Access Compliance Report

Public Rights-of-Way

Intersection ID: 10038352	Main Street: SOUTH_BV	Cross Street: N/A	Location: NE
ADA ID: A37240332817	Ramp Type: PerpDiag	Initial Pass/Fail: Fail	Overall Compliance: No
		Severity Score: 12.5

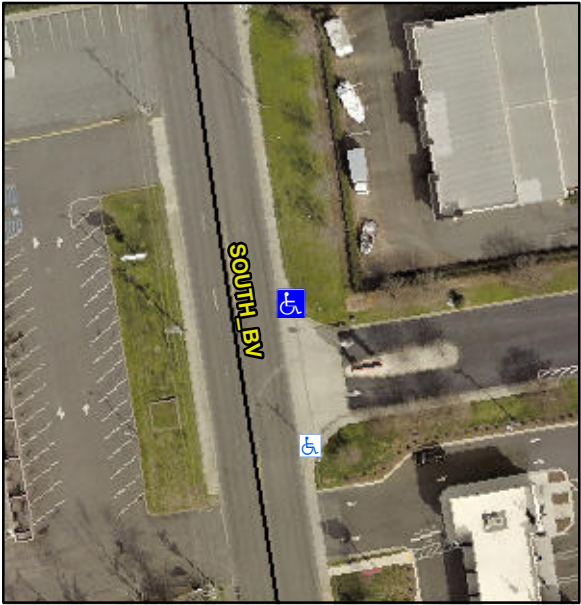
Codes/Mitigation Info/Possible Solution			Field Measurements/Component Compliance		
	Possible Solutions:		Compliance	Description	Data
	Remove & Replace Curb Ramp With Two New Directional Ramps or Equivalent.		Yes	Ramp Length (in)	61.0
			N/A	Ramp Width (in)	58.0
			N/A	Flare Type LT	N/A
			N/A	Flare Slope LT (%)	N/A
			N/A	Flare Traversable LT?	N/A
			N/A	Landing Length (in)	N/A
			N/A	Landing Width (in)	N/A
			N/A	Landing Slope (%)	N/A
			N/A	Landing X Slope (%)	N/A
<p>Surveyor Notes:</p> <p>N/A</p> <p>PROW/ADA:</p> <p>Not Found, R304.5.3</p>			N/A	Flare Type RT	N/A
			N/A	Flare Slope RT (%)	N/A
			N/A	Flare Traversable RT?	N/A
			N/A	DWS Provided?	N/A
			N/A	DWS Contrast?	N/A
			N/A	DWS Length (in)	N/A
			N/A	DWS Full Width?	N/A
			N/A	DWS Offset (in)	N/A
			N/A	Gutter Ponding?	N/A
			N/A	Gutter Lip Ht (in)	N/A
			No	Painted X Walk1?	No
			To W	X Walk 1 Direction	To S
			N/A	X Walk 1 Width (in)	N/A

1.3	X Walk 1 Slope (%)	2.7
			0.2	X Walk 1 X Slope (%)	5.6
			N/A	Ramp inside XWalk1?	N/A
			0.0	Road Slope (%)	N/A
			1.8	Road X Slope (%)	N/A
			N/A	Any Obstructions?	N/A
				Obstruction Type	
Total Cost: \$ 3200.00			N/A	Storm Grate/Utility Hazard?	N/A
			N/A	Storm Grate/Utility Type	N/A
			Yes	Surface Condition? (G/P)	Good
